SERVICE BULLETIN

#0020 Revision 1

SUBJECT: Eyebolt inspection and conditional replacement

Figure 16: Flap Controls

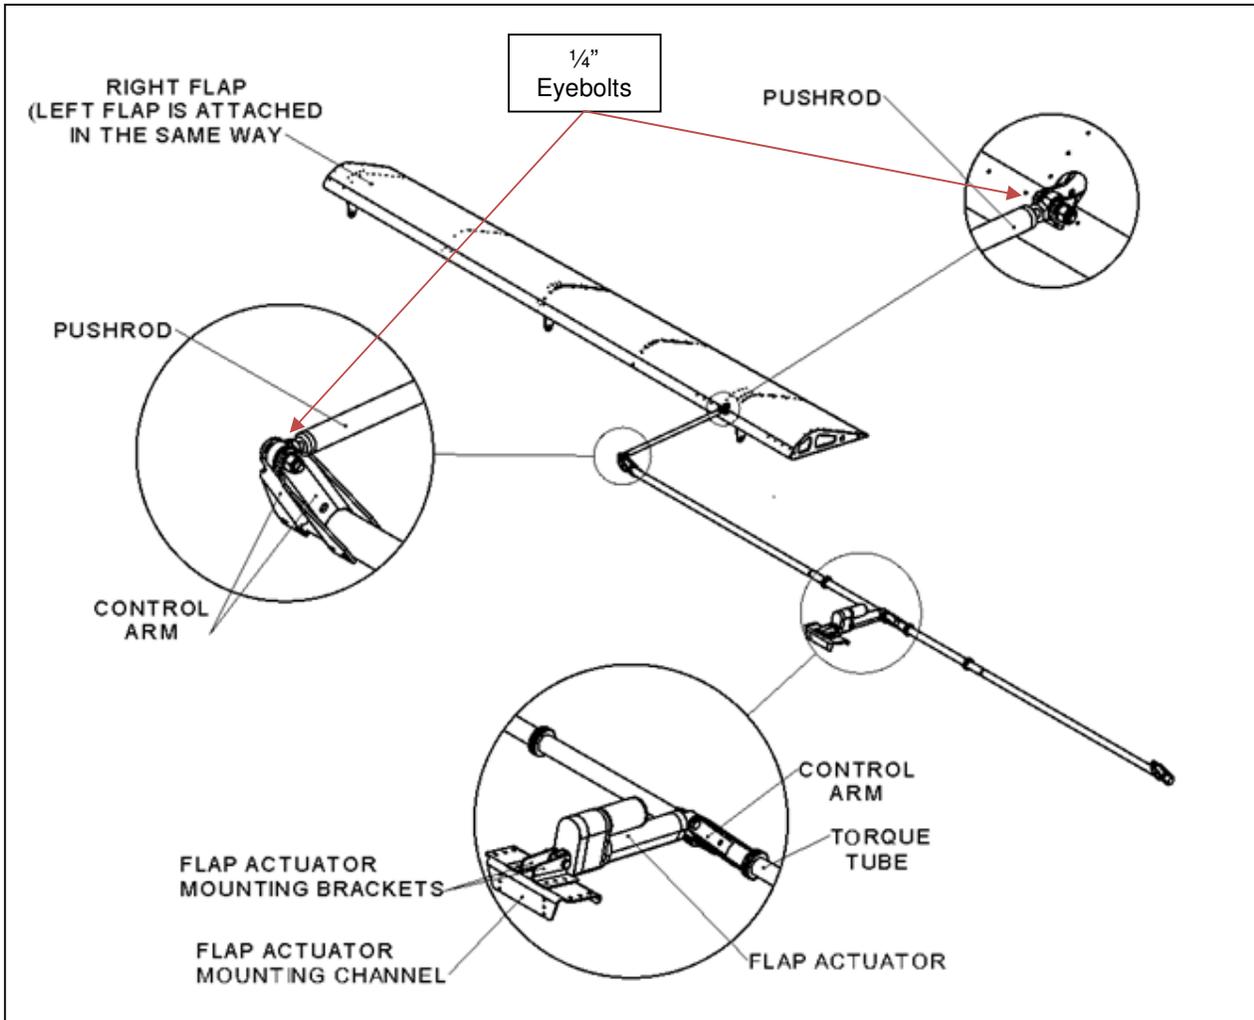
The eyebolts used in the flap control assembly can be seen in Figure 16. These can be inspected using the inspection hatches located on the wing. Due to symmetry only one flap has been shown. The same eyebolts will be found on the other side of the aircraft. The eyebolts need to be inspected and replaced where *noncompliant eyebolts* have been installed.

Figure 17: Sling 2 and Sling LSA elevator control system

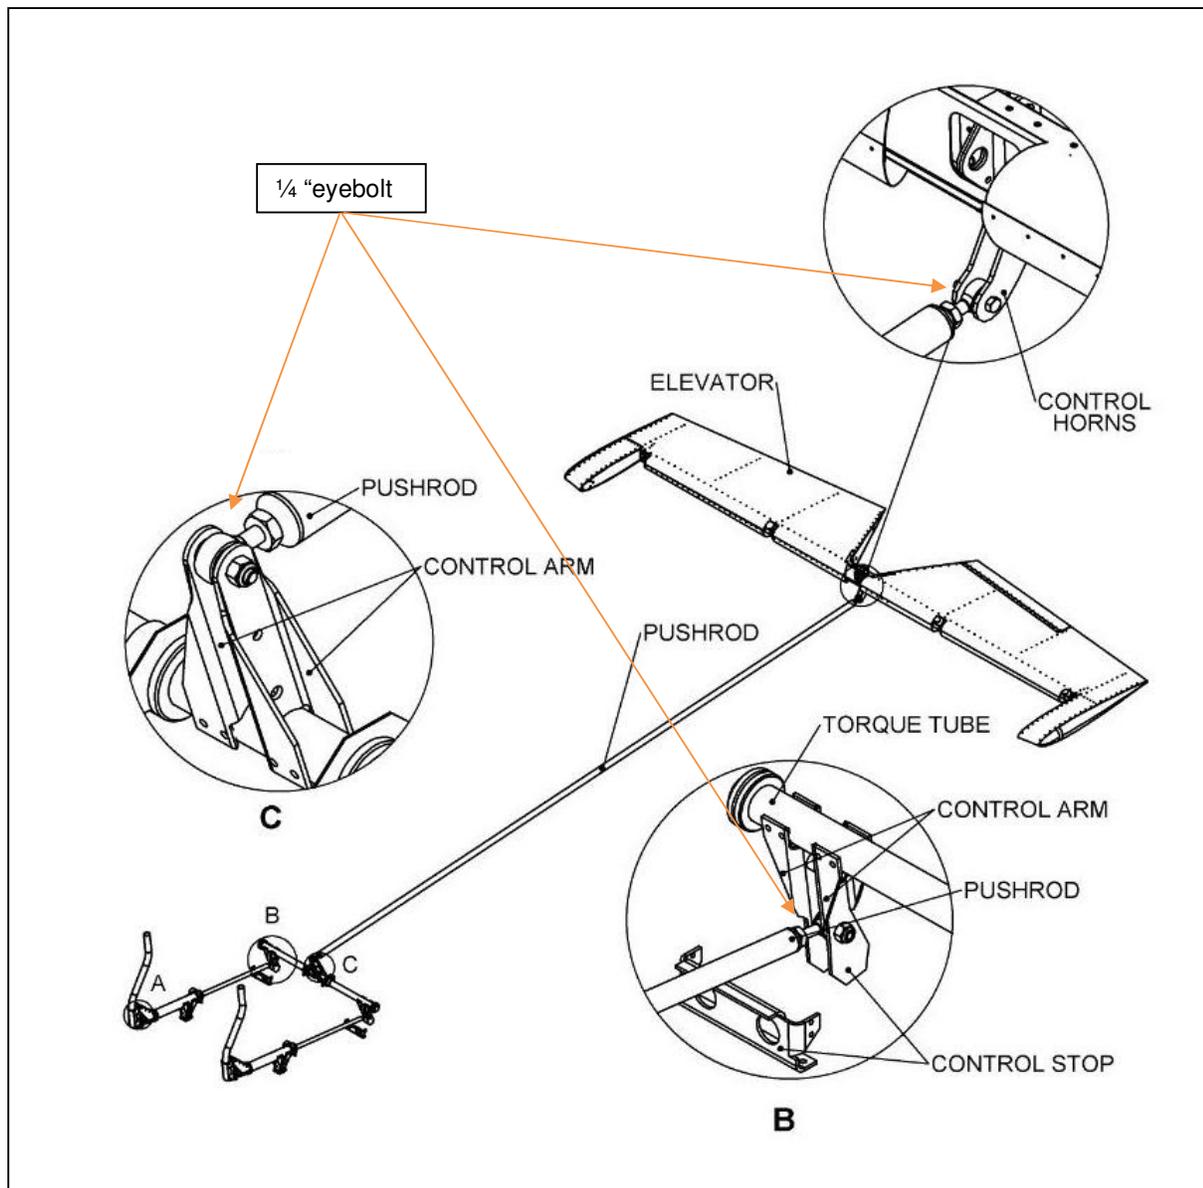
This section is only applicable to the Sling 2 and Sling LSA. The eyebolts used in the Sling 2 and Sling LSA elevator controls can be seen in Figure 17.

- Step 1. Ensure the seats and control covers have been removed, as stated in Section 3.2.2.
- Step 2. Inspect the eyebolts seen in Detail C of Figure 17. An exploded view of Detail C can be seen in Figure 18.

Figure 18: Eyebolt assembly, Detail C

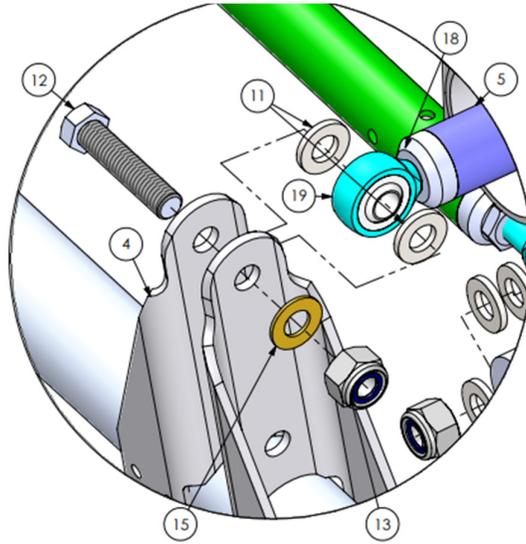
- Step 3. Refer to Figure 18. If a *noncompliant* eyebolt has been used, it must be replaced (with either a *type 1* or *type 2*). To do this, remove the AN4 locknut (13) and bolt (12). The eyebolt can now be uninstalled from the pushrod and a new one can be installed.
- Step 4. Once the new eyebolt has been installed onto the pushrod, reconnect the eyebolt assembly. Refer to Figure 18 for part layout.
- Step 5. Next, the eyebolts seen in Detail B of Figure 17 will need to be inspected and replaced if found to be *noncompliant*.
- Step 6. An enlarged view of Detail B can be seen in Figure 19.

Figure 19: Enlarged view of eyebolt assembly of Detail B

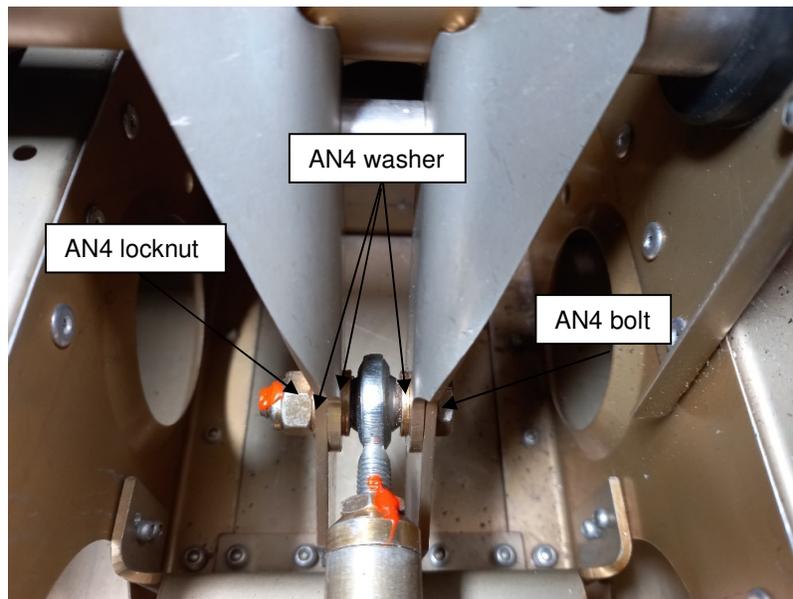
- Step 7. Refer to Figure 19 and remove the locknut and bolt.
- Step 8. Replace the *noncompliant* eyebolt with a *type 1* or *type 2*.
- Step 9. Reinstall the components, as shown in Figure 19.
- Step 10. Repeat Step 7 to Step 9 for the corresponding eyebolt assembly on the other side of the aircraft.

Figure 20

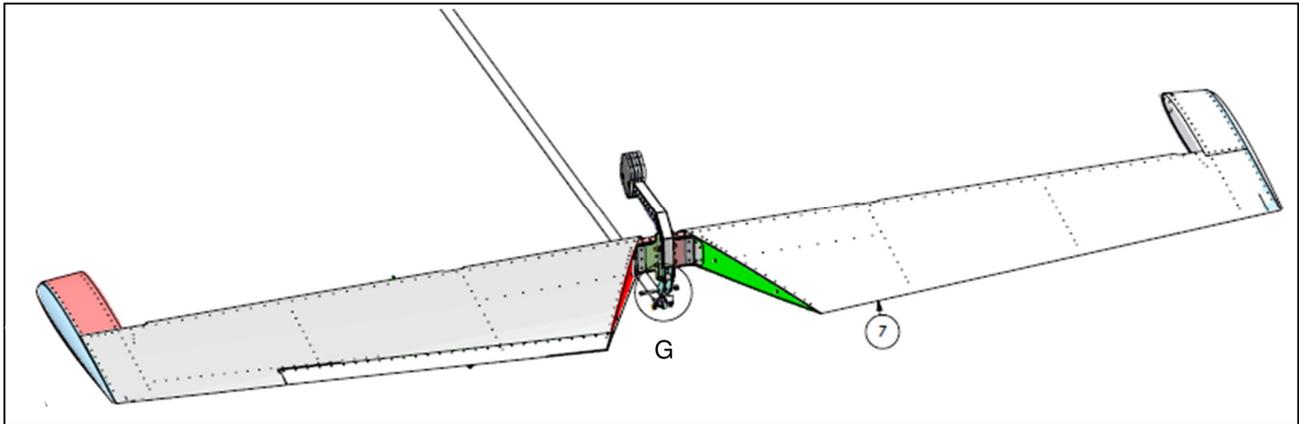
Step 11. The last eyebolt that needs to be inspected and replaced is the one connected to the elevator horn in detail G of Figure 20.

Figure 22: Detail G

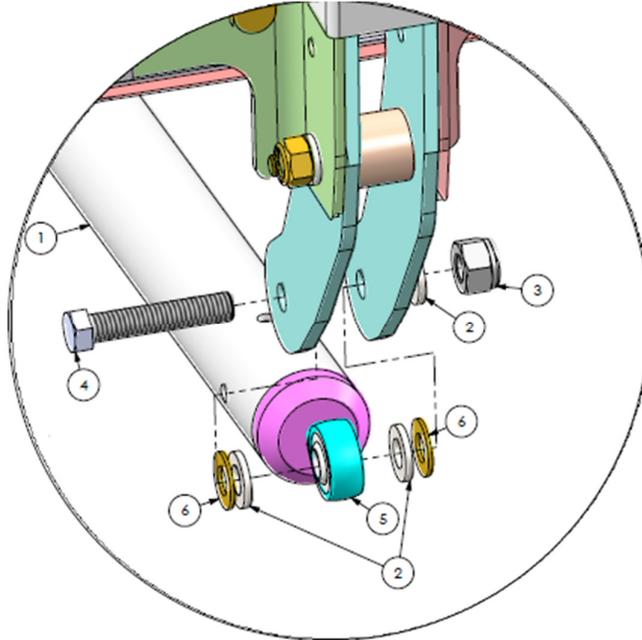
Step 13. Remove the AN4 locknut (3) and bolt (4), shown in Figure 22.

- Step 14. Replace the *noncompliant* eyebolt (5) with either a *type 1* or *type 2*.
 Step 15. Reassemble the eyebolt assembly as seen in Figure 22.
 Step 16. You will need to adjust the elevator once the new eyebolts are installed to ensure correct elevator deflection. To do this follow the instructions in the applicable MAM shown in the table below:

Figure 23

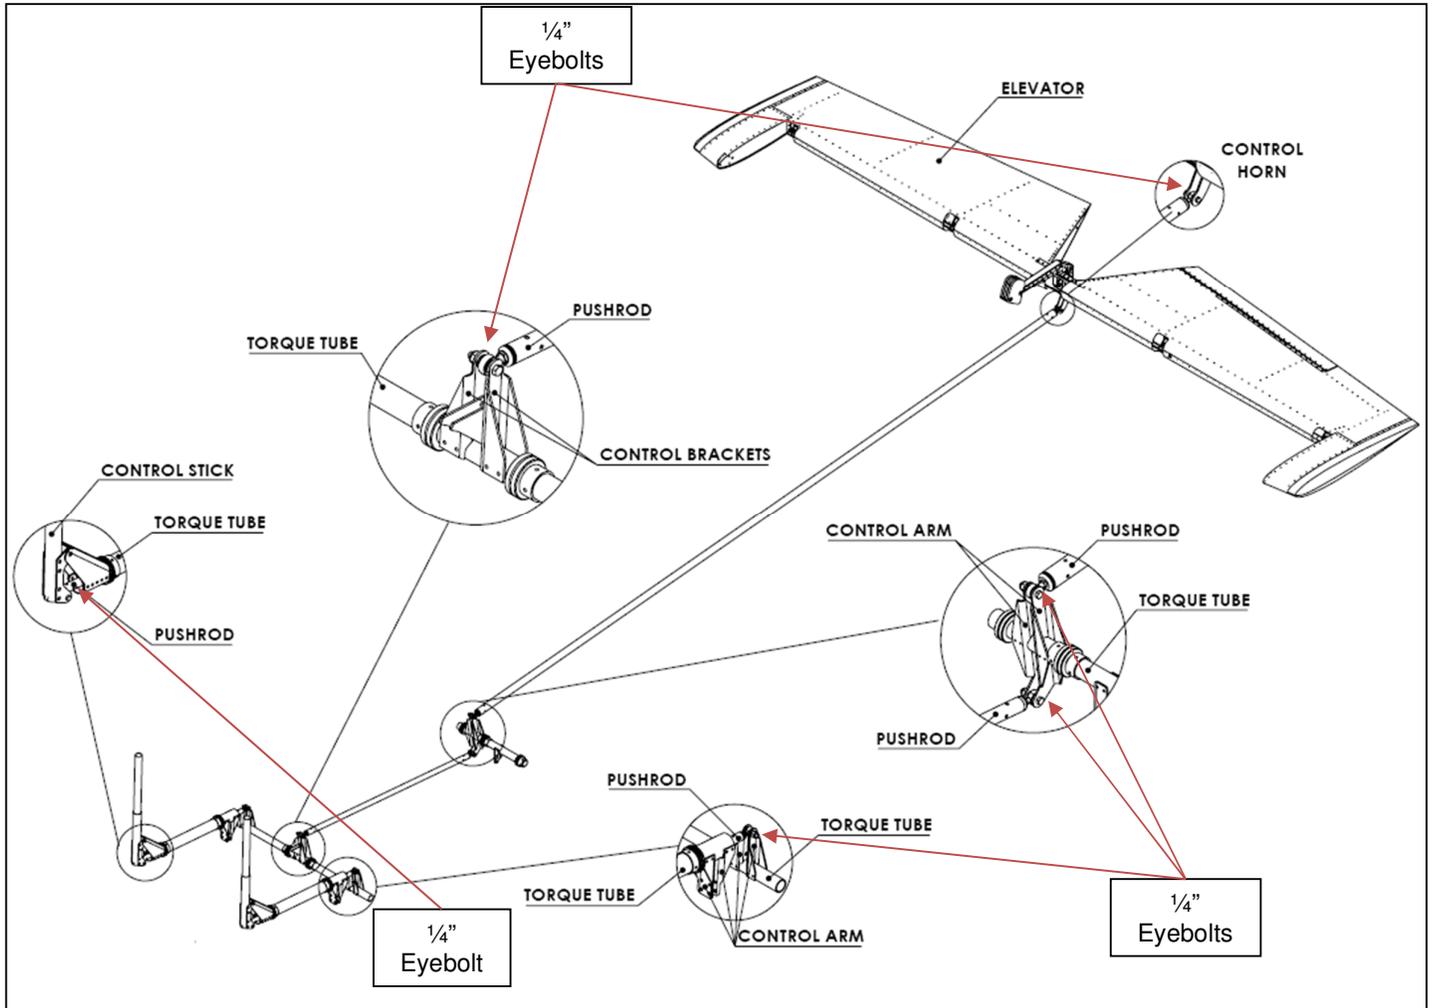
This section is only applicable to the Sling 4 and Sling 4 TSi. The eyebolts used in the elevator controls can be seen in Figure 23. The eyebolts need to be inspected and replaced where *noncompliant* eyebolts have been installed.

Figure 24: Eyebolt assembly, Detail A

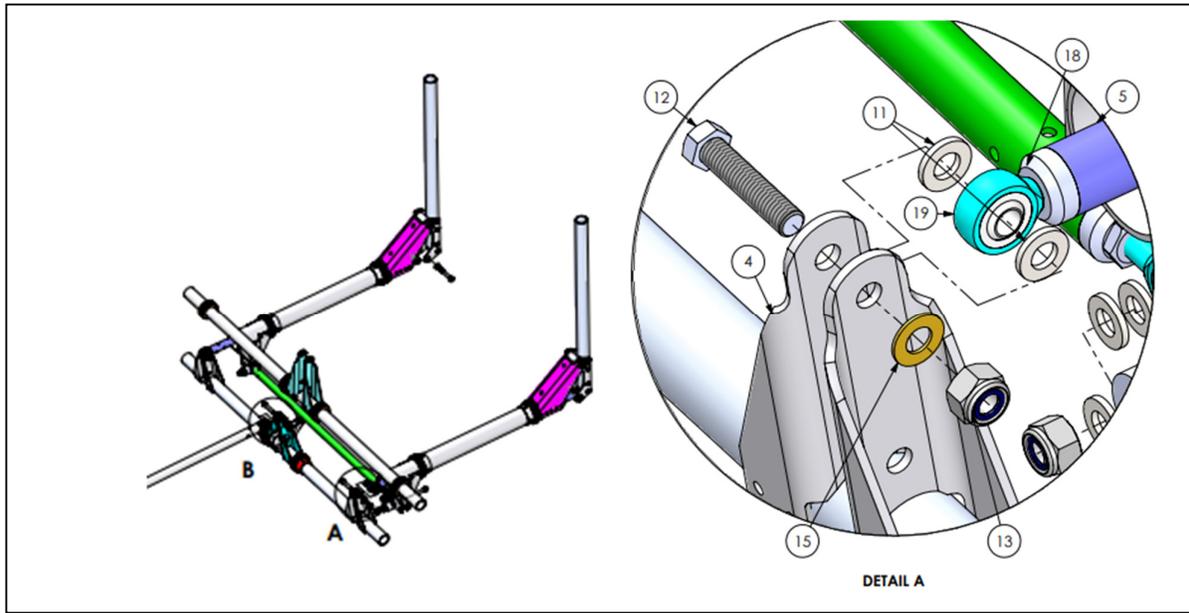
- Step 3. If *noncompliant* eyebolts have been used, they must be replaced (with either *type 1* or *type 2*). To do this remove the AN4 locknut (13) and bolt (12), as seen in Figure 24. The eyebolt can now be uninstalled from the pushrod. Once uninstalled, install a new one of either *type 1* or *type 2*.
- Step 4. Once the eyebolt has been installed onto the pushrod, reconnect the eyebolt assembly. Refer to Figure 24 for the way the assembly fits together.
- Step 5. Next inspect the eyebolts seen in Detail B of Figure 25.

Figure 25: Eyebolt assembly, Detail B

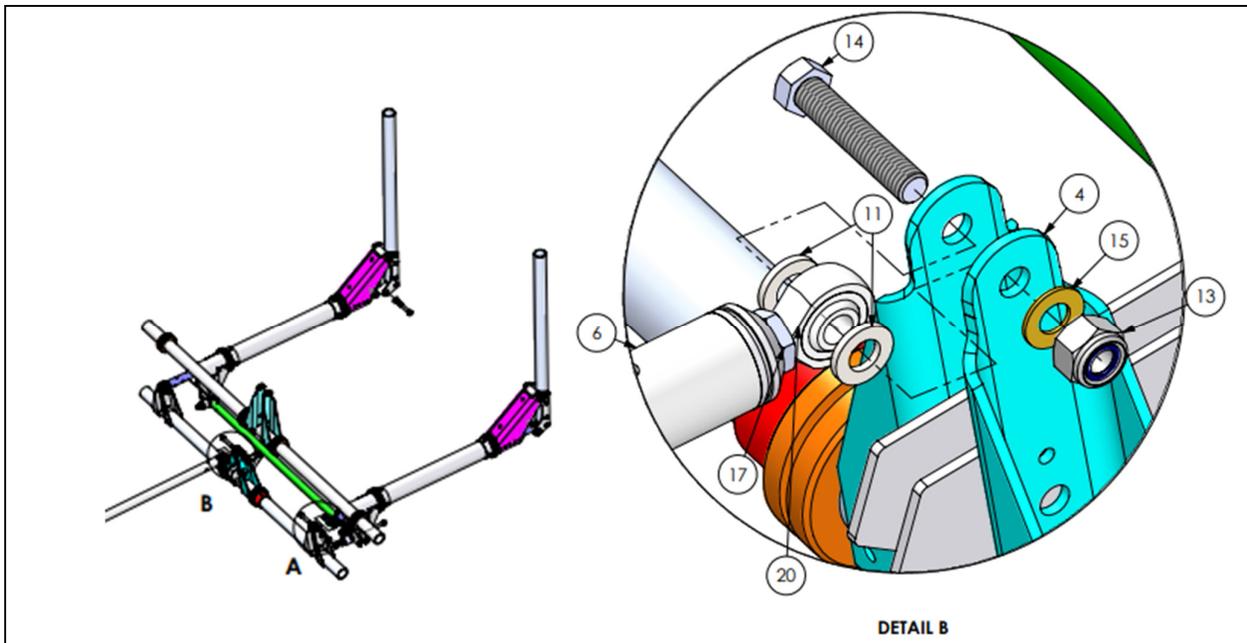
- Step 6. Remove the AN4 locknut (13) and bolt (14), as seen in Figure 25. Once removed the eyebolt can be uninstalled and an eyebolt of *type 1* or *type 2* can be reinstalled.
- Step 7. Reassemble the eyebolt assembly, refer to Figure 25 for part placement.

Figure 26

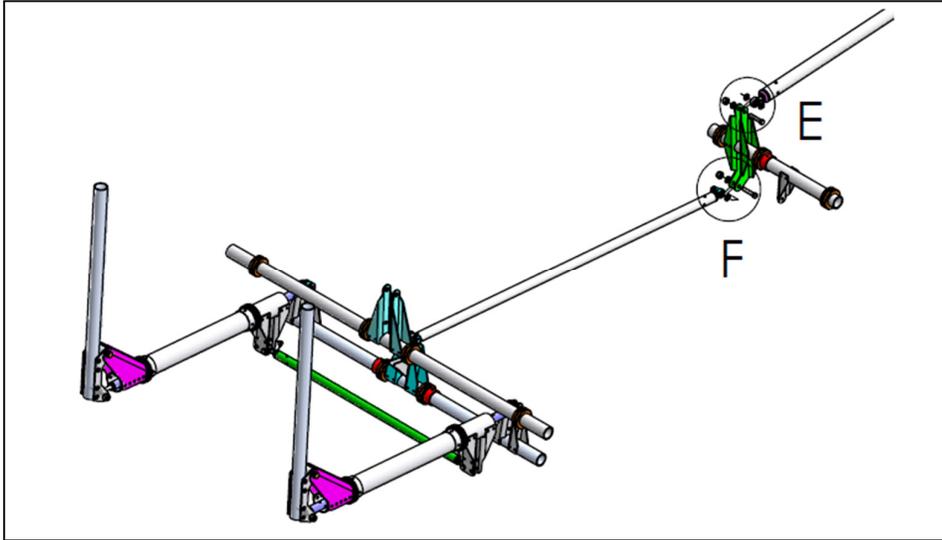
Step 8. Next, the eyebolts seen in Detail E and F in Figure 26 will need to be inspected and replaced if found to be of *noncompliant*. To access these in the Sling 4 TSi, remove the rear seats. To do this follow the instructions in the applicable MAM shown in the table below:

Figure 27: Eyebolt assembly, Detail E

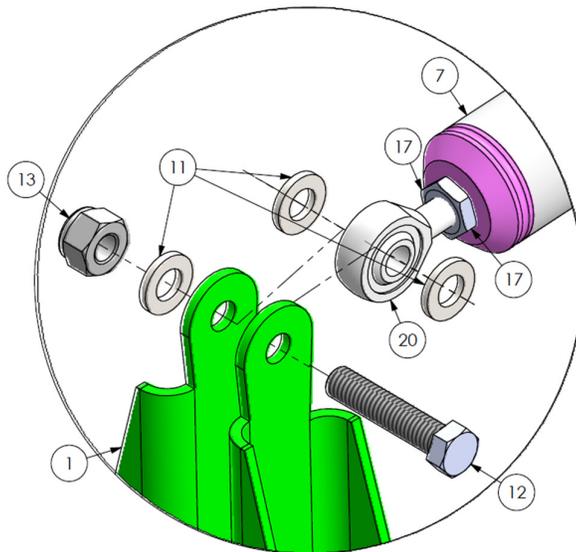
Step 9. To replace the eyebolt seen in Figure 27, remove the AN4 locknut (13) and bolt (12). Replace the *noncompliant* eyebolt (20) with either a *type 1* or *type 2* eyebolt.

Figure 28: Eyebolt assembly, Detail F

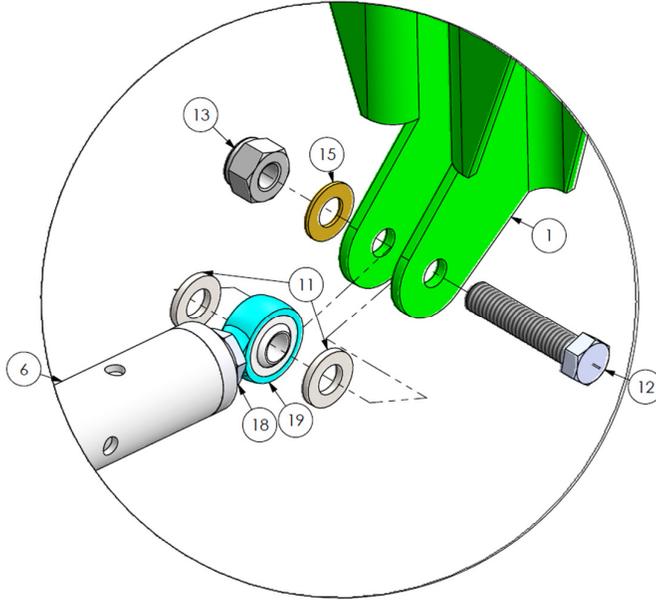
Step 11. To replace the eyebolt seen in Figure 28, remove the AN4 locknut (13) and bolt (12). Replace the *noncompliant* eyebolt with either a *type 1* or *type 2* eyebolt.

Figure 29

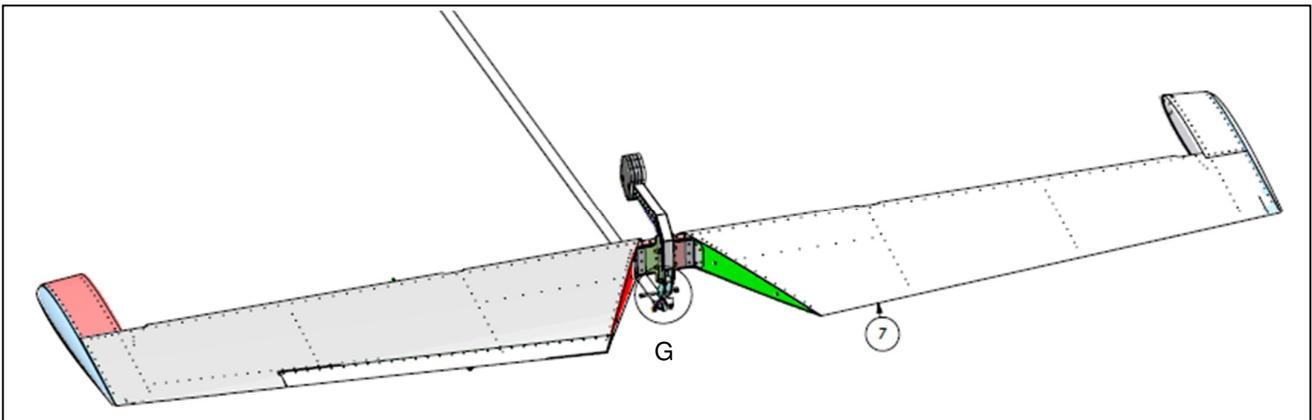
- Step 12. Once the eyebolt has been replaced, reconstruct the eyebolt assembly. Refer to Figure 28 for component layout.
- Step 13. The last eyebolt that needs to be inspected and replaced is the one connected to the elevator horn, located in detail G of Figure 29.

Figure 31: Detail G, exploded view

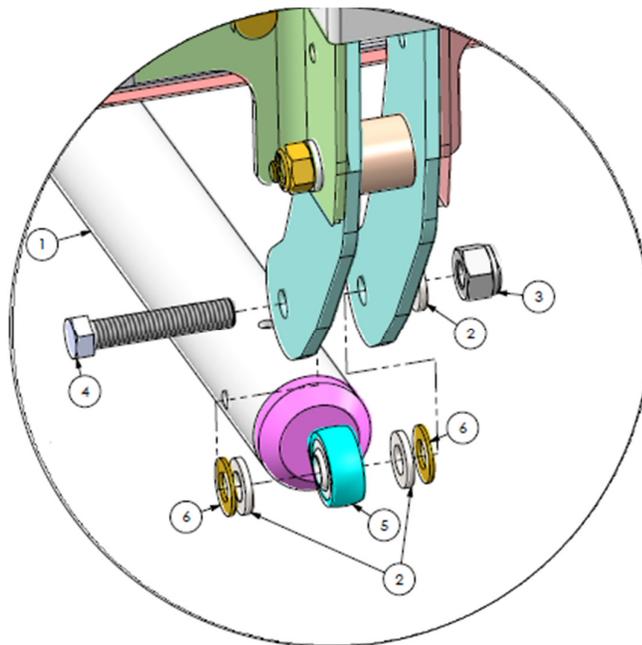
Step 15. Remove the AN4 locknut (3) and bolt (4), shown in Figure 31.

Step 16. Replace the eyebolt (5) with either a *type 1* or *type 2*.
